AGENDA ITEM SUMMARY REPORT

APPLICATION NO.: Coastal Development Permit 9-18 (CDP 9-18)
Design Review 3-18 (DR 3-18)
Minor Subdivision 1-18 (DIV 1-18)

PROJECT: Coastal Development Permit, Design Review, and Minor Subdivision to construct a 7,500 SF AutoZone retail store with 26-space parking lot and associated improvements and infrastructure. The existing 2.5-acre parcel is vacant and the proposed subdivision would create two lots. Lot 1 on the northern portion of the site would be the site of the proposed retail store. No development is proposed for the southernmost lot at this time.

LOCATION: 1151 S Main Street, Fort Bragg

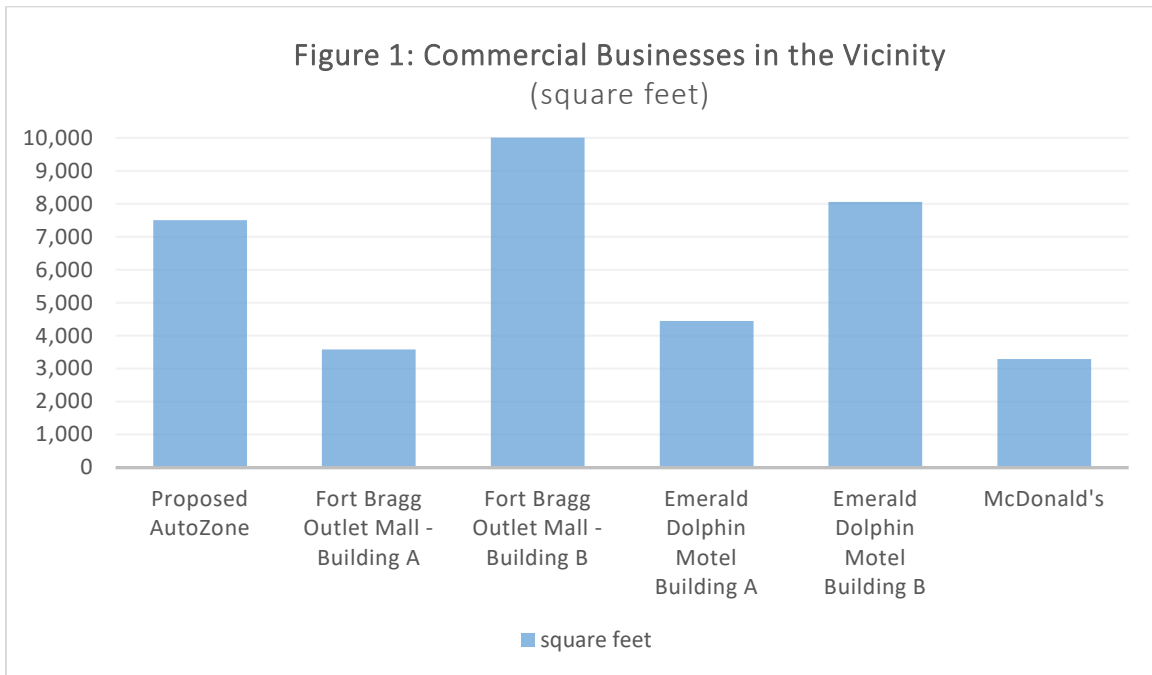
Scale: New development is comparable in scale with existing buildings and streetscape. Figure 1 depicts the scale of the proposed retail store, relative to established businesses in the vicinity. As shown, the size of the proposed retail store is comparable with other buildings in the immediate vicinity and would not detract from the economic vitality of established commercial businesses.
